SAN LUIS OBISPO COUNTY
DEPARTMENT OF PUBLIC WORKS
Paavo Ogren, Director

ADDENDUM NO. 1 TO
REMOVAL AND REPLACEMENT OF THE RESERVOIR LINER AT THE SANTA MARGARITA BOOSTER STATION RESERVOIR
SANTA MARGARITA, CA
CONTRACT NO. 535R155715

LINER ATTACHMENT DETAIL

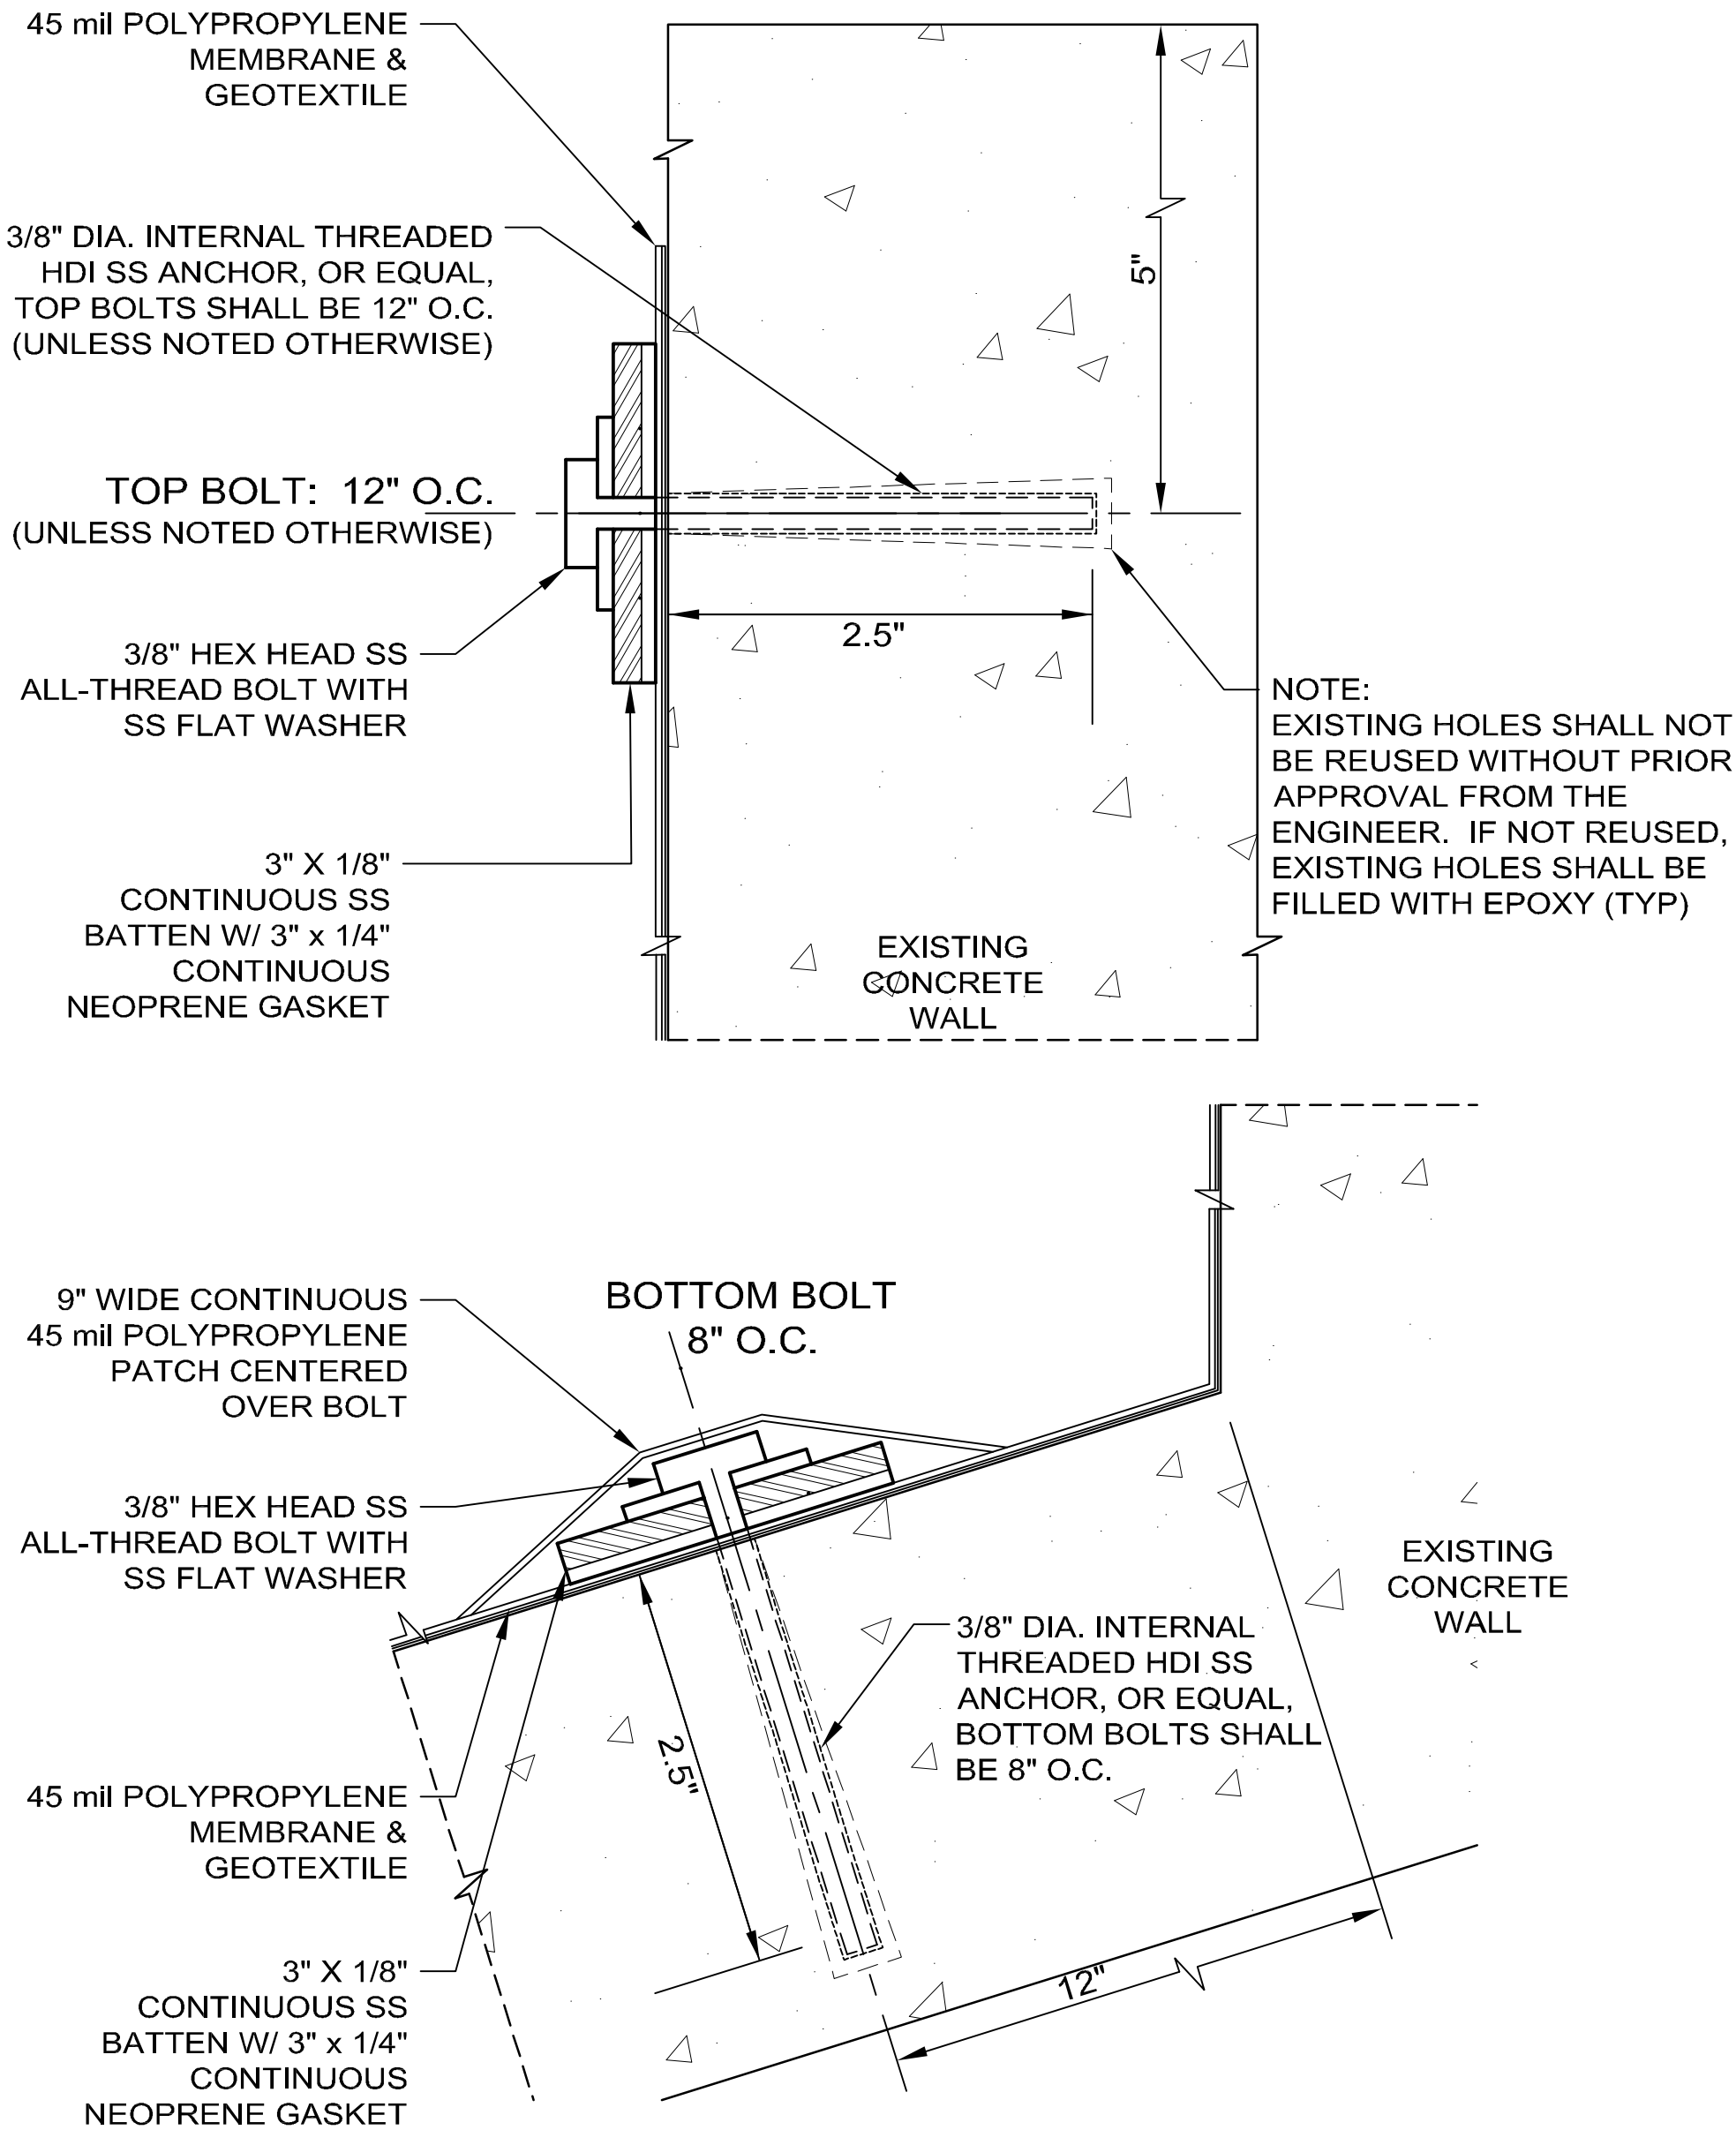
5) Replace the "LINER ATTACHMENT DETAIL" on Sheet 3 with the Liner Attachment Detail attached to this addendum. It should be noted that the details showing the 3" square SS anchor plates and neoprene gaskets have been changed to require continuous 3" SS battens and neoprene gaskets for liner anchors / attachments.
